# Access Compliance Report

## Public Rights-of-Way

Intersection ID: 50607	Main Street: DENBUR_DR	Cross Street: STREAM_ORCHID_LN	Location: SW
ADA ID: D3CB4F9E900F	Ramp Type: Perp	Initial Pass/Fail: Fail	Overall Compliance: No
Severity Score: 10			
Codes/Mitigation Info/Possible Solution		Field Measurements/Component Compliance

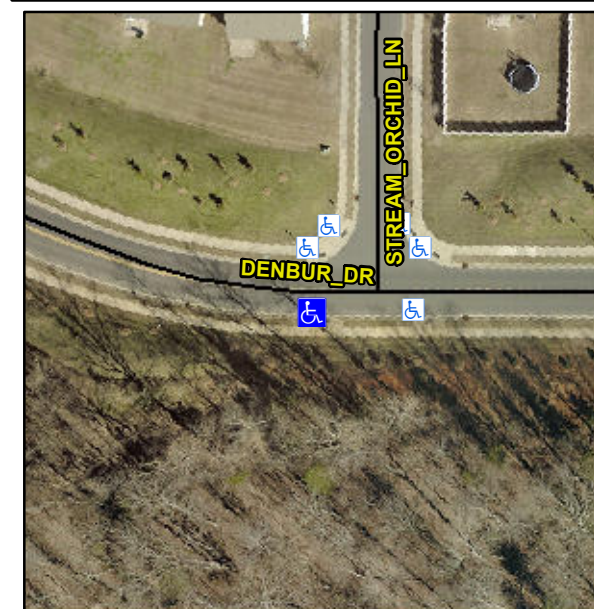
**Remove & Replace Entire Ramp.**

**Not Found, R304.5.1**
